Software changes 20240618

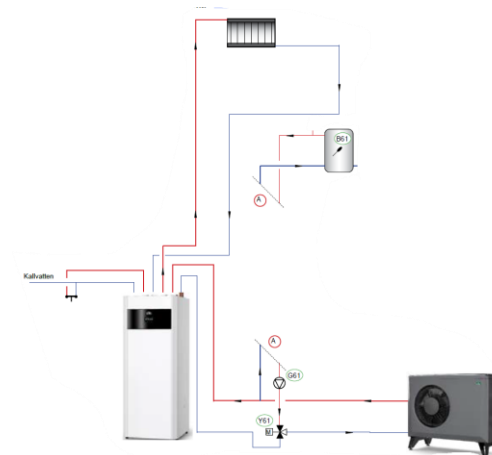
New: Added new option have only cooling tank without heating or cooling system connected to it

- This is a new choice in the menu... Menu "only tank". This system is only cooling a tank, control of fan coils etc is **not done by CTC** but with external controller
- CTC controls the tank temperature not the temperature after the tank, towards the system.
- Define/cooling/cooling tank (Yes/No, new option, **ONLY TANK**)

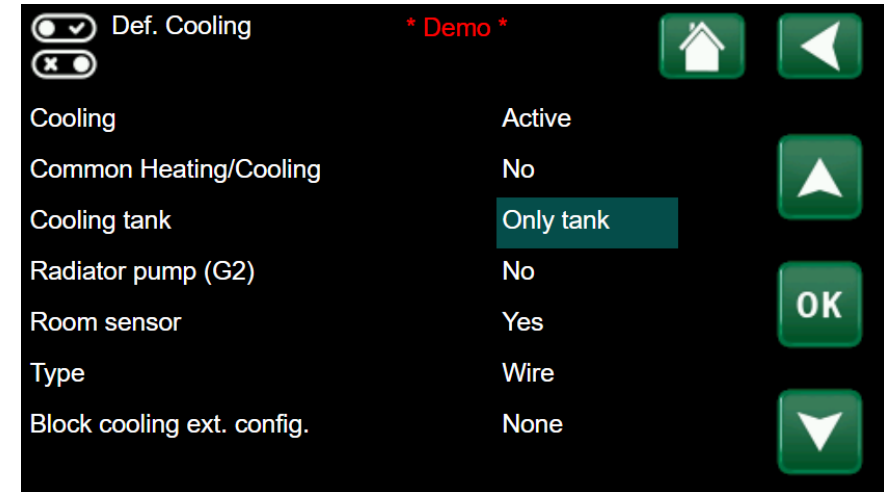
Bug fix: showed room setpoint for cooling even when room sensor wasn't used

- If no room sensor is used, you will see the primary flow temperature.
- This is for the heating/cooling temperature
